# Fresh air hose loose from air filter housing

REF NO:	ISSUING DEPARTMENT:	CAR MARKET:		
TJ 31319	Technical Service	United States and Canada		
	PARTNER:	ISSUE DATE:	STATUS DATE:	
3 US 7	7510 Volvo Car USA	2016-04-06	2016-04-12	
FUNC GROUP:	FUNC DESC:			
2560	Air cleaner and throttle housing	Page	1 of 3

# **Technical Journal 31319**

File Name	File Size
TJ31319.jpg	0.0582 MB

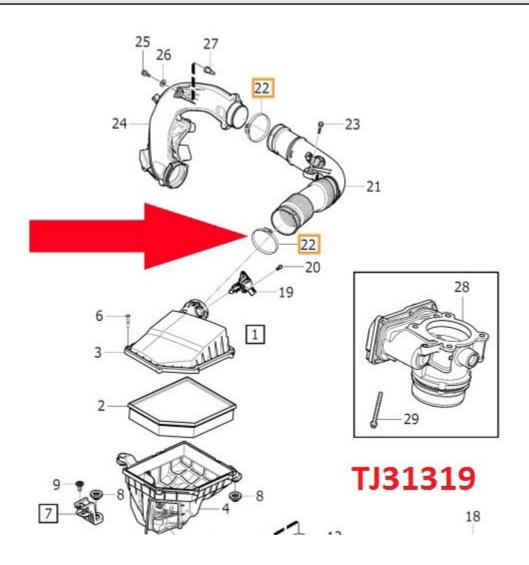
If the "check engine" indicator is lit and ECM-P226200 and/or ECM-P02CD00 is posted, this can be caused by loose fresh air hose at MAF sensor.

ECM-P200200 may be posted as a consequential failure.

If fresh air hose is loose from air filter housing, install spring clamp P/N 988016 to prevent repeat repair. Tightening torque 4 Nm.

See attachment.
